# SS 715-WST 2021 49X Transmission Cooler Line Plumbing Fitting

## **Applicable Vehicles**

49X vehicles built with manual or automated manual transmissions.

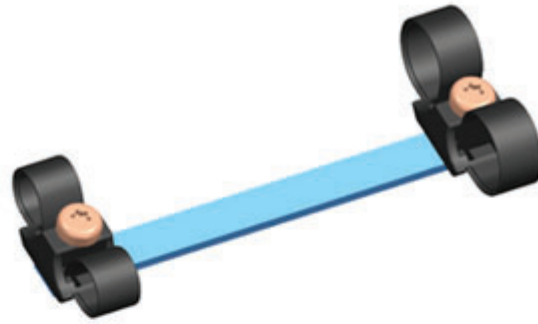
Transmission cooler line plumbing fitting connections at the radiator may have relative movement between rail and radiator allowing fittings to become loose and leak.

Retainer assembly

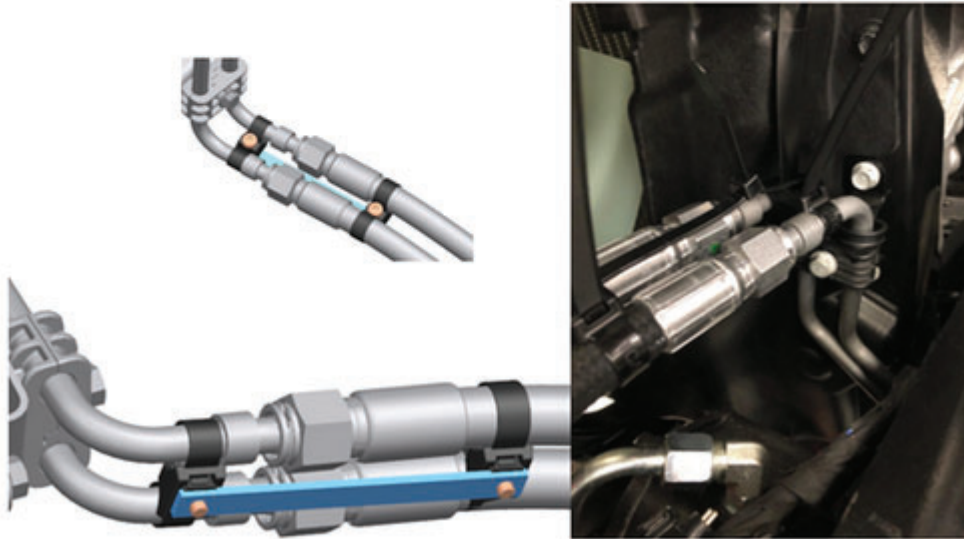
Install parts below to existing trans cooler plumbing lines as shown:

TYCDCT110HIR Tie cable dual, .375 to 2.25 quantity(2)

23-12781-725 SCR-MACH,PNH HDL,LKG,M6.25 quantity(2)

07-25565-000 BAR-RETAINER,PLUMBING quantity(1)
